SUBJECT: **NEW VEHICLE DEMONSTRATION / DELIVERY HOLD**
Customer Satisfaction Program 20B14 – Supplement #2
 Certain 2020 Model Year Escape Full Hybrid Electric Vehicle
 Powertrain Control Module Update

**NEW VEHICLE DEMONSTRATION / DELIVERY HOLD
Customer Satisfaction Program 20B14 – Supplement #2
Certain 2020 Model Year Escape Full Hybrid Electric Vehicle
Powertrain Control Module Update**

CERTAIN 2020 MODEL YEAR ESCAPE FULL HYBRID ELECTRIC VEHICLE — POWERTRAIN CONTROL MODULE REPROGRAM

FIGURE 1

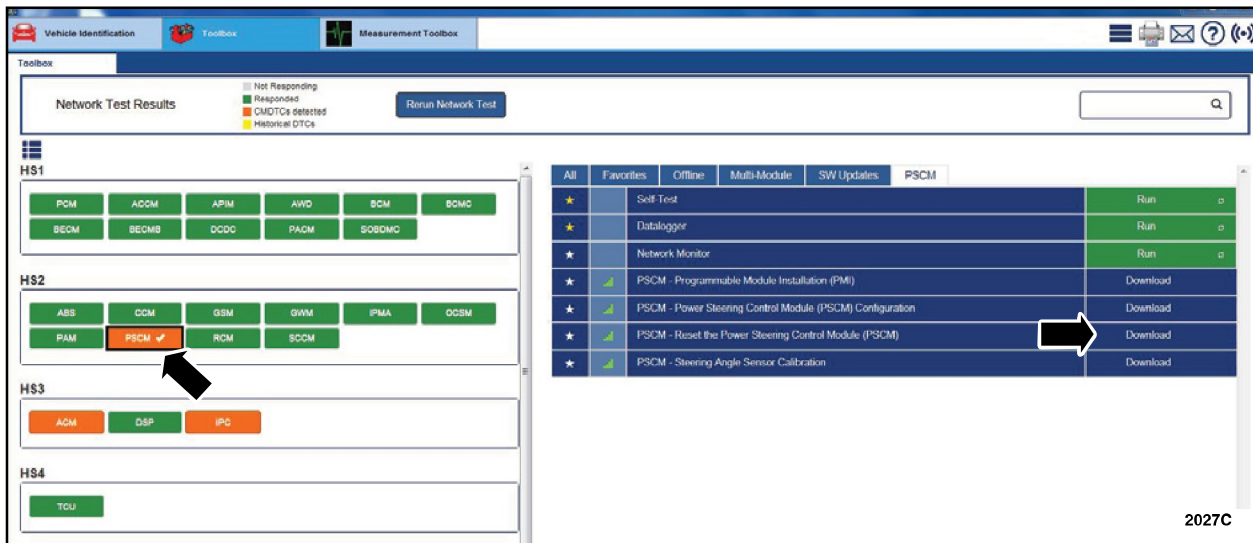
12. Under the tool box tab select "PSCM" and select download "PSCM - Reset the Power Steering Control module (PSCM)". See Figure 1. Select Run after the download.

FIGURE 2

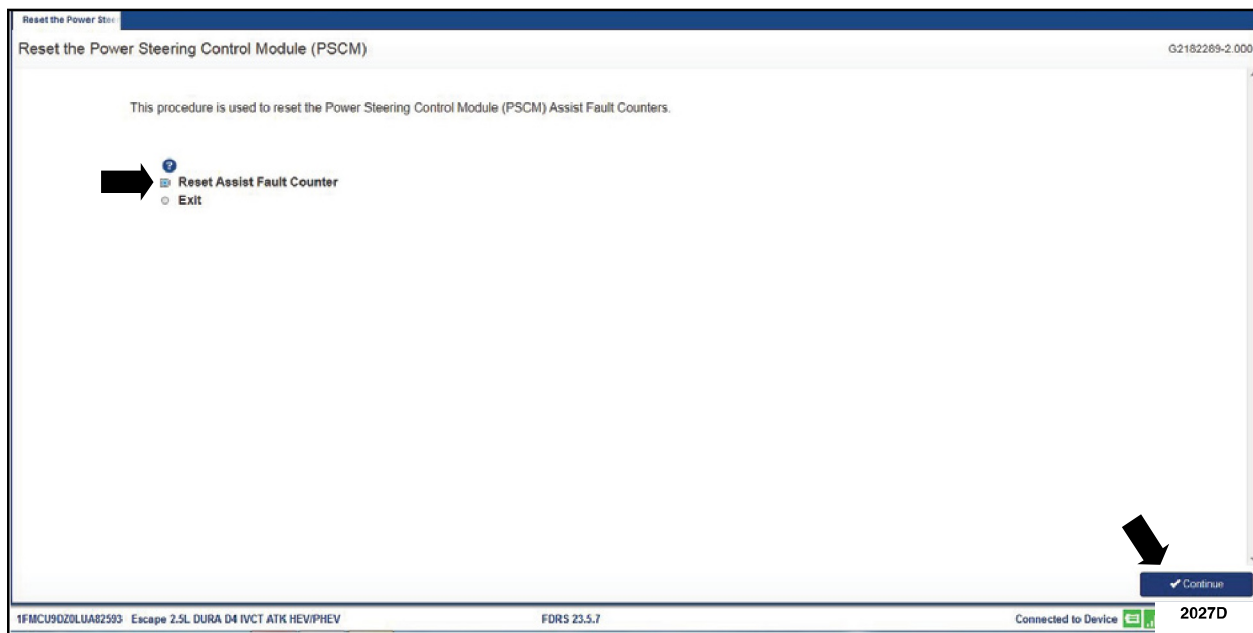
13. Select "Reset Assist Fault Counter" and then "Continue". See Figure 2.
